Technical Bulletin

New Terminal Material on SA Switch Series SA 16-27

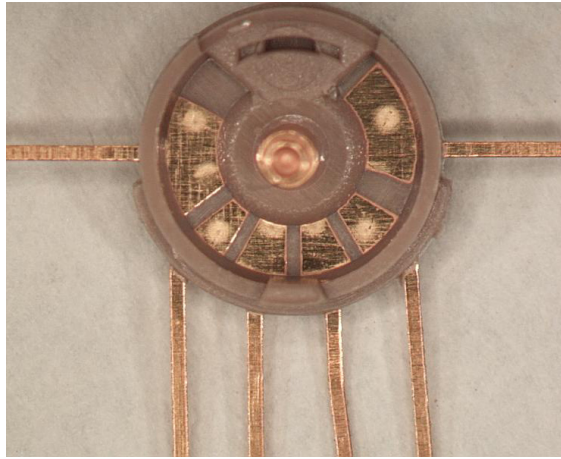
Therefore, we are pleased to announce that we have achieved a more reliable SA switch series by changing to a new contact terminal material (CuNiZn, gold flash plated).

The change in material can not be visually identified, as it appears similar to the previous material (gold plated). This improved material has been gradually implemented since week 01/2006. Consequently, all terminals in the SA16-27 series being ordered today have completely changed over to the superior material. This improvement will have no influence on the part numbers that you order today.
